# Access Compliance Report

## Public Rights-of-Way

| Intersection ID: 9386                   | Main Street: DUCKWOOD_LN | Cross Street: SAM_DEE_RD                | Location: SW           |
| ADA ID: 4049F2026C7C                    | Ramp Type: BlendTrans1   | Initial Pass/Fail: Fail                 | Overall Compliance: No |

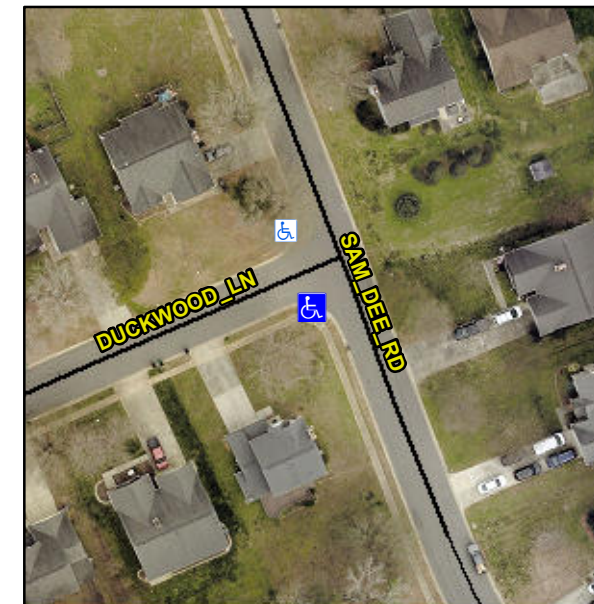
**Remove & Replace Curb Ramp With Two New Directional Ramps or Equivalent.**

**Not Found, R304.5.1, R304.5.3**

| Compliance | Description           | Data | Compliance | Description                 | Data |
|------------|-----------------------|------|------------|-----------------------------|------|
| No         | Ramp Width (in)       | 47.0 | No         | BlendTrans XSlope (%)       | 5.5  |
